Site Name: Land at Docks Way, Newport

Report Reference: WWE26082 Land at Docks Way - Fencing Plan

Date: 08/06/2026

Figure 2:
Security Fence, Gate and CCTV Camera (Version A – Issue 1)) Dulas Fencing plan submitted 04/01/2024

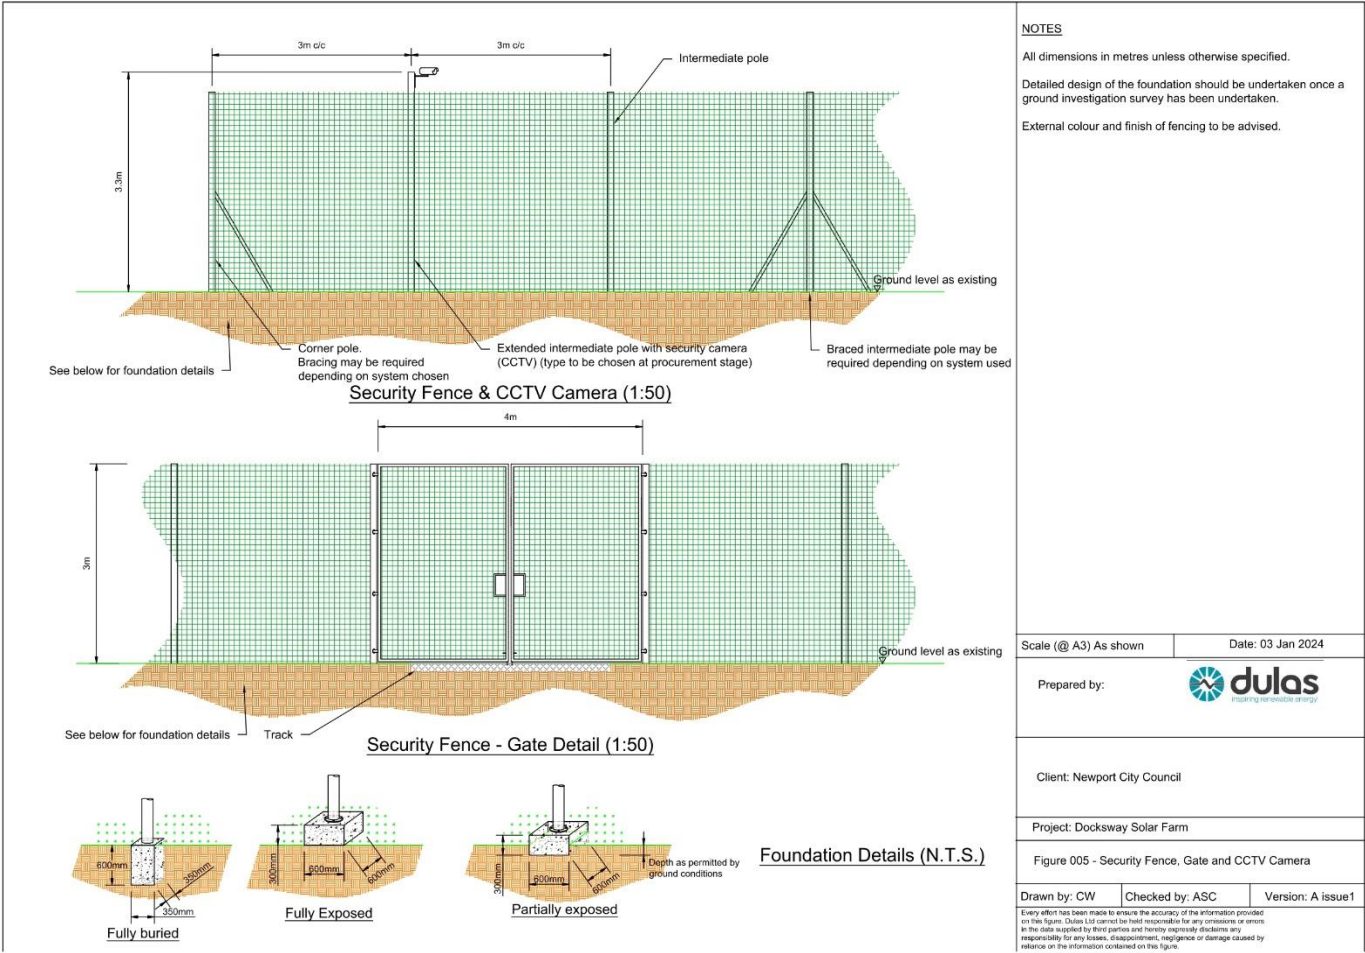
Fencing plans have previously been submitted alongside proposals for this site (Figure 005 – Security Fence, Gate and CCTV Camera (Version A – Issue 1)) Dulas. See Figure 3 below. This current fencing is proposed to bound the entirety of the site. See figure 4 below. Under these current fencing proposals access for commuting mammals would be obstructed to site, thereby potentially obstructing access to otter.

It is therefore advised that alterations be made to either the fencing, or gaps be created below the proposed fencing in order to keep the site accessible to commuting mammals, while still providing security for the site.

While razor or barbed wire has not been included within the current fencing proposals, otters are skilled climbers and may attempt to access the site over the fence rather than under it. It is therefore advisable that barbed or razor wire not be implemented on any fencing, as this may harm or kill any otters attempting to access the site.

Figure 3: Approximate size of created gap within fencing plan

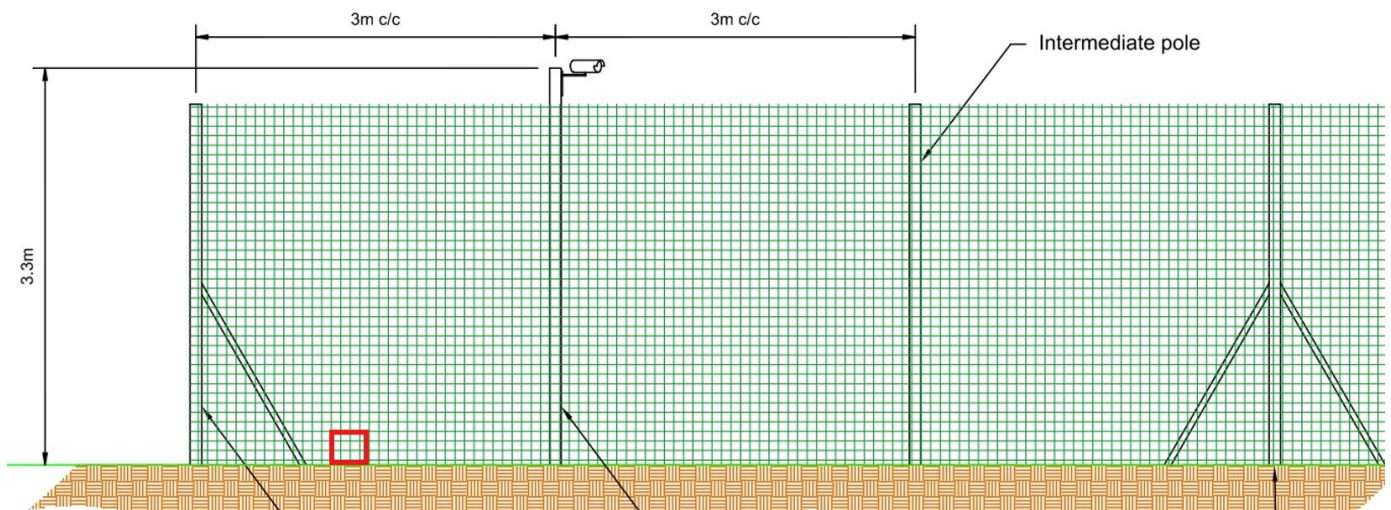
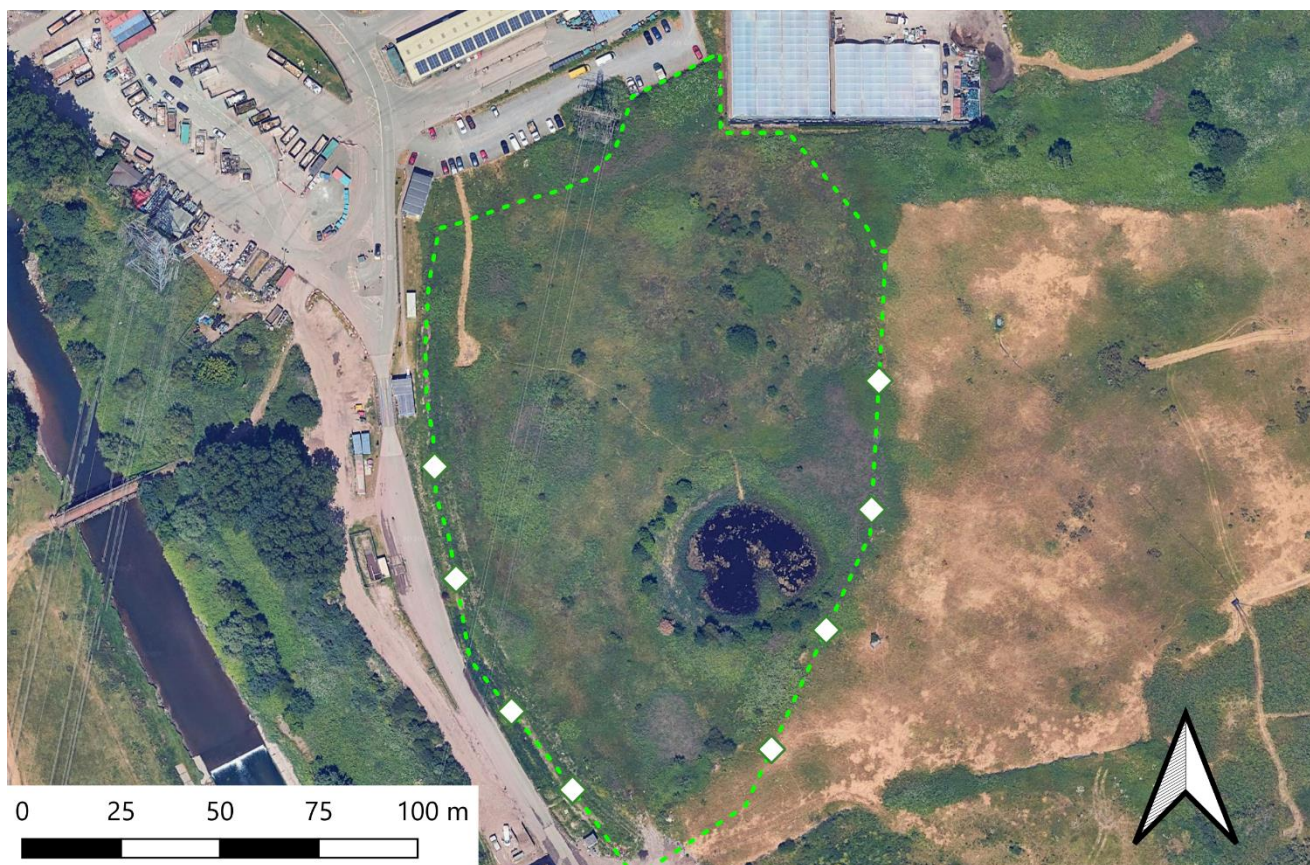
The current proposed fence could have intermittent gaps created after their installation, or during their fabrication. These gaps should be approximately 13 x 13 cm to allow adult otters, as well as other commuting mammals (i.e. hedgehogs, badgers), to access the site. The gaps should be created at the base of the fence, so it is easily accessible for commuting mammals. If these gaps are cut into the fence after installation, care must be taken to ensure that no sharp or jagged edges are left that may injure wildlife passing through.

See Figure 3 below for the approximate size of a 13 x 13cm gap in relation to the current fencing proposals.
